April 29, 1994
LD-94-032

Docket No. 52-002

Subject: Response to Comments on Design Certification Material

CE 80 + ITAAC Independent Review Comments

FIGURE 5.0-1
HORIZONTAL FREE FIELD SURFACE SPECTRA
AT FINISHED PLANT GRADE LEVEL

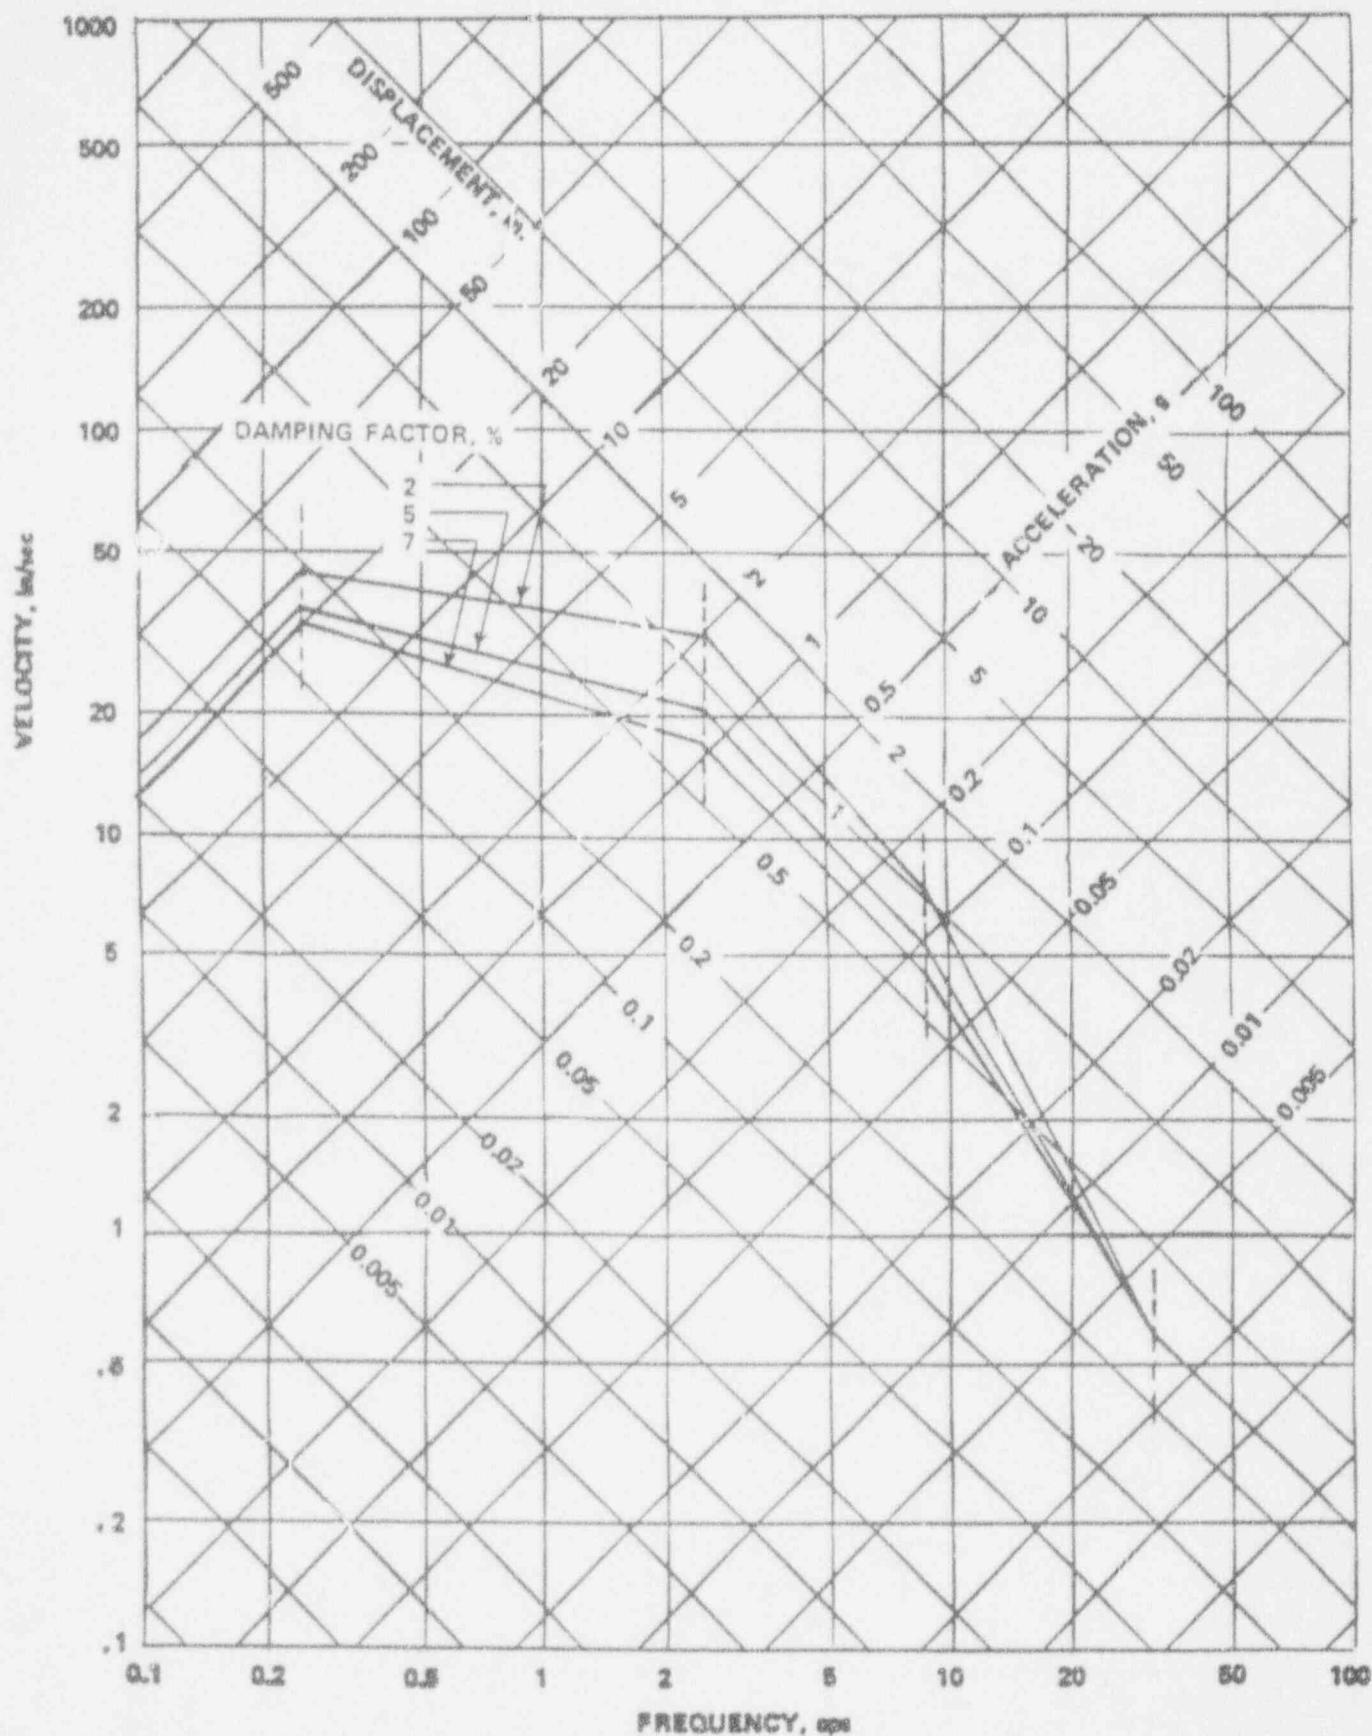
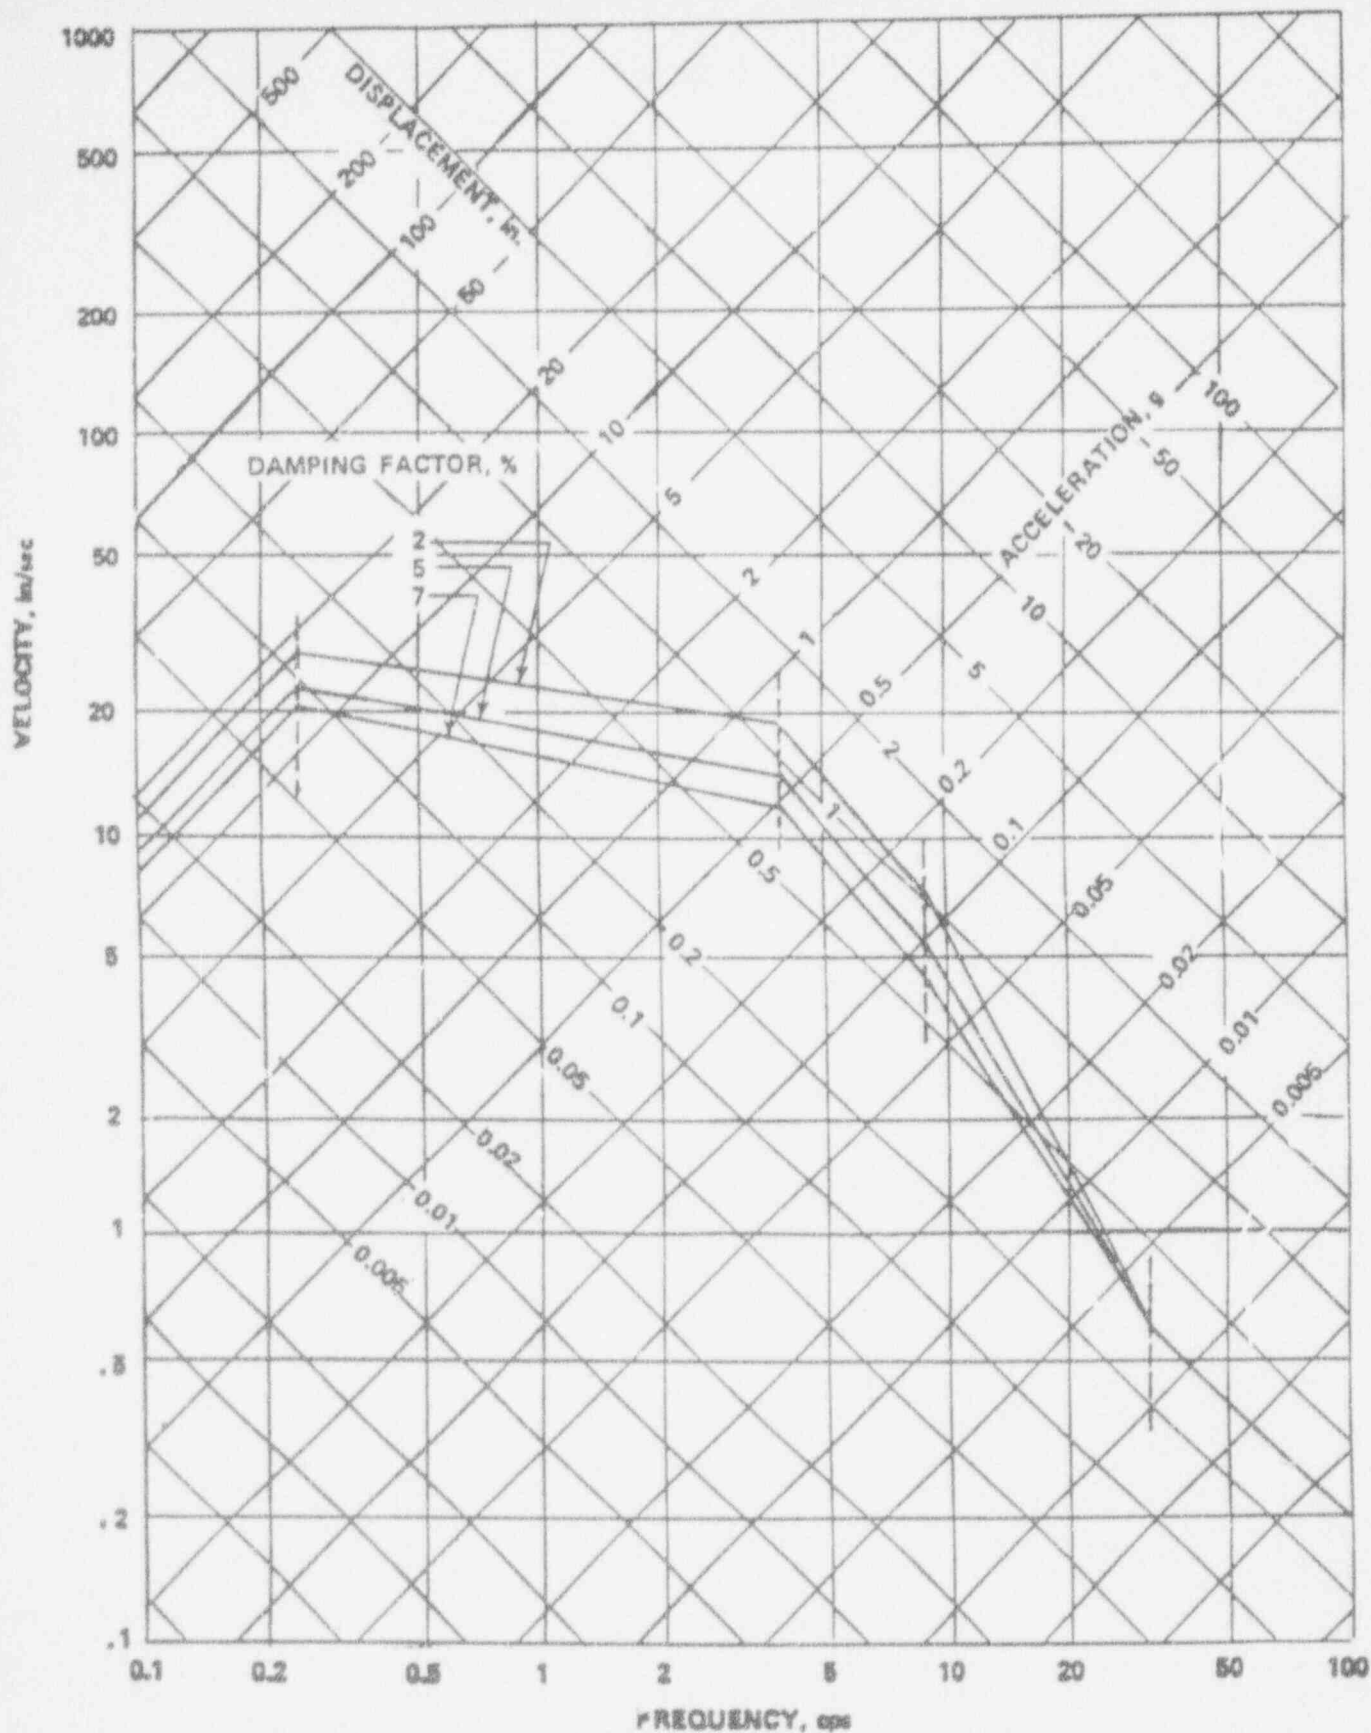
No.	Comments	Cat.	Resolution
1	As this section does not have an ITAAC, revise the site parameters text to include the following (equivalent to Section 4.0) "An application for a combined license (COL) that references the System 80+ Certified Design must describe how the actual site location characteristics are bounded by the site parameters."	2	Agree with modification. See markup. Note: Attached Figures 5.0-1 and 5.0-2 fulfill a commitment in letter LD-93-178 to provide such figures scaled to 0.3 g.

FIGURE 2.4.6-1
CONTAINMENT SPRAY SYSTEM
(ONE OF TWO DIVISIONS)

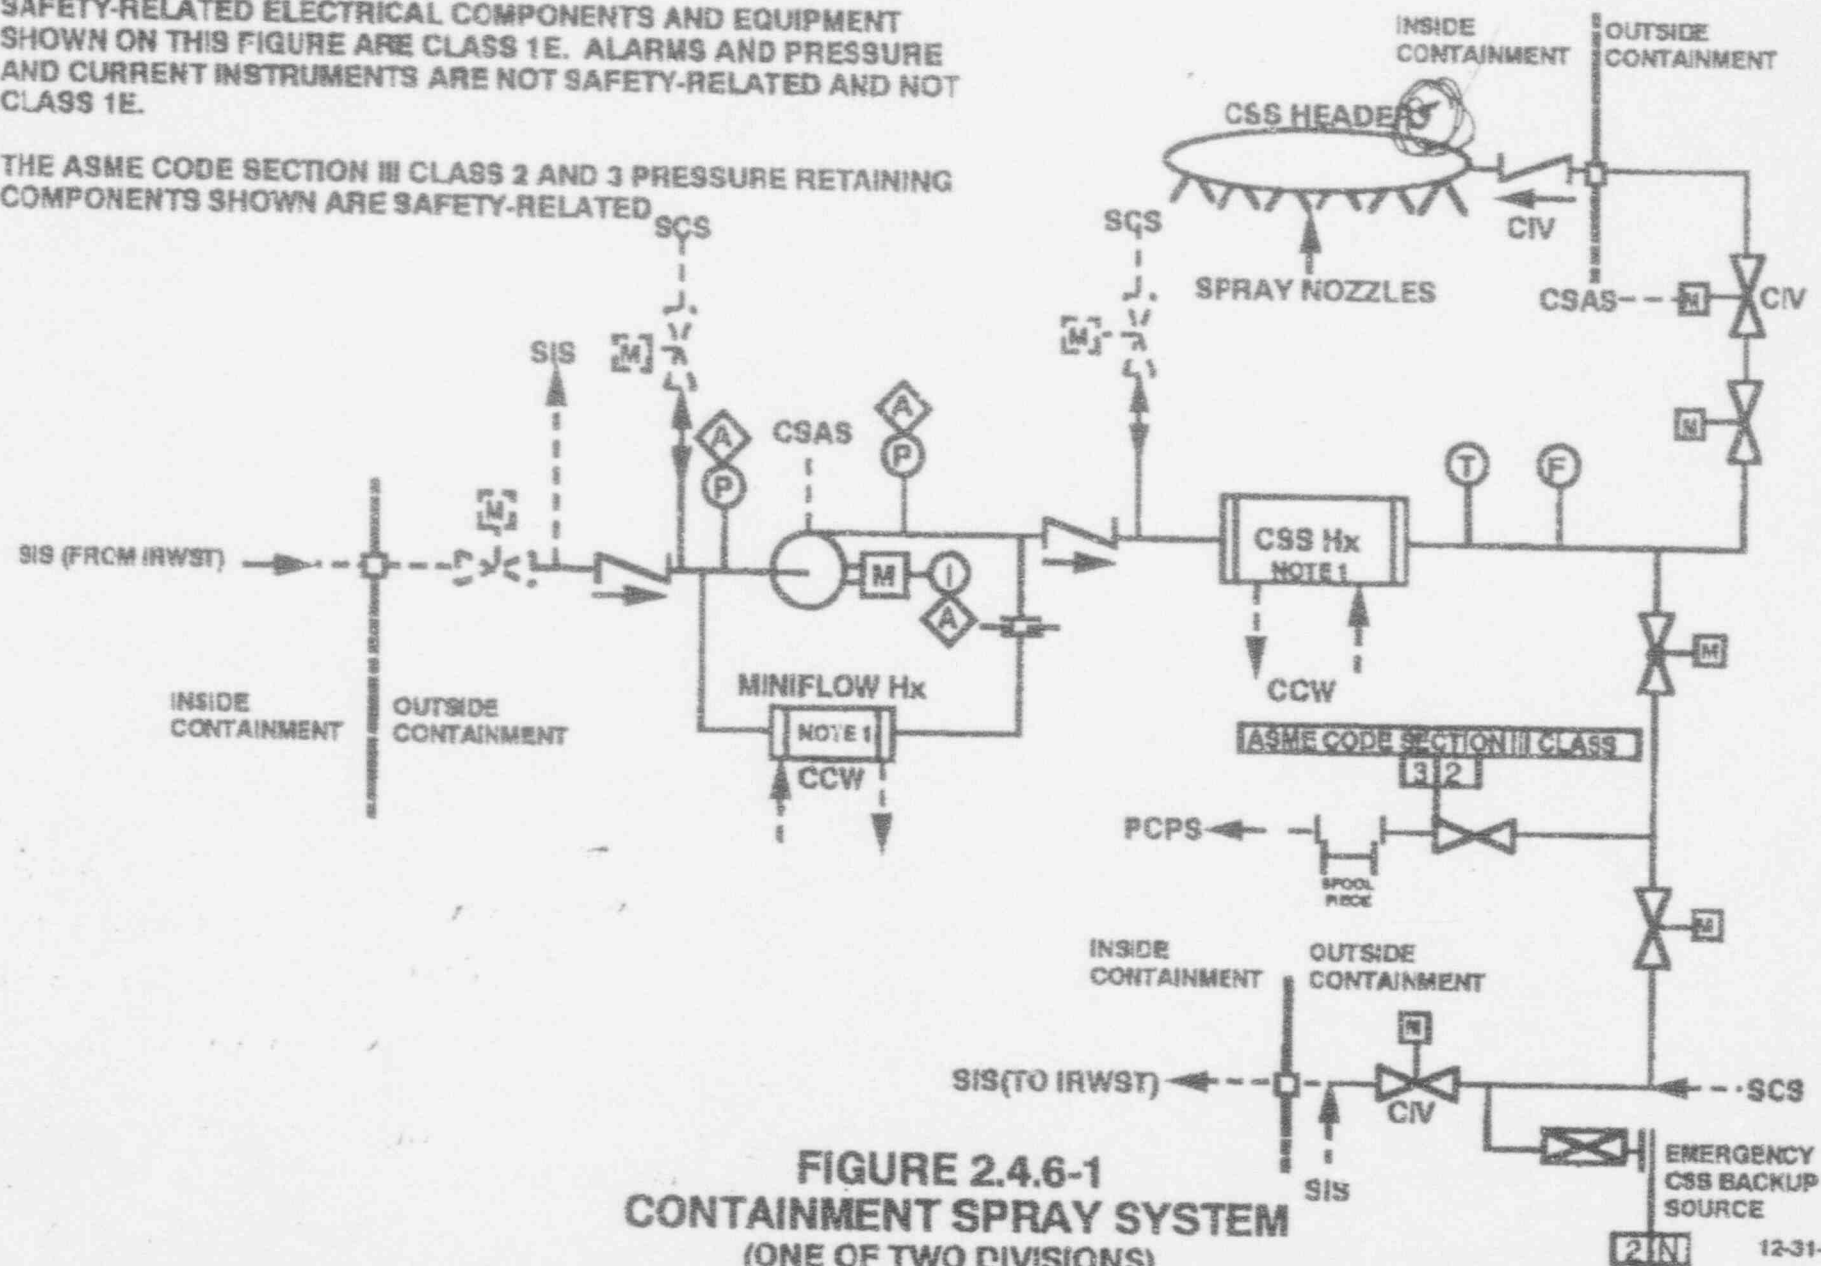
No.	Comments	Cat.	Resolution
1	<p>Page 2, 6th paragraph and Figure 2.4.6-1 showed that "The CSS pumps are started upon receipt of a containment spray actuation signal (CSAS),---.", whereas in various CESSAR sections (6.5.1.1, 7.3.1.1.10.2, 7.3.2.2.1) and P&ID Figure 6.3.2-1 showed that "The containment spray pumps starts upon the receipt of a Safety Injection Actuation Signal (SIAS) or a Containment Spray Actuation Signal (CSAS)." Please resolve this discrepancy.</p>	1	<p>ABB-CE disagrees. Both an SIAS and a CSAS are provided to start the containment spray pump. However, only the pump start on CSAS, not on SIAS, is credited in the Chapter 6 and 15 safety and containment analyses. Therefore, only the pump start on CSAS is verified in Tier 1.</p> <p>NRC Staff concurs.</p>
2	<p>Page 2 paragraph 7 discussed MOVs with active safety function. Does this statement apply to all MOVs of Figure 2.4.6-1? Please confirm.</p>	1	<p>ABB-CE agrees. All Containment Spray System MOVs shown on Figure 2.4.6-1 perform an active safety function. CESSAR DC Table 3.9-4 will be revised to add containment spray IRWST recirculation line isolation valves SI-686 and SI-696, as shown on the attached markup.</p> <p>NRC Staff concurs.</p>
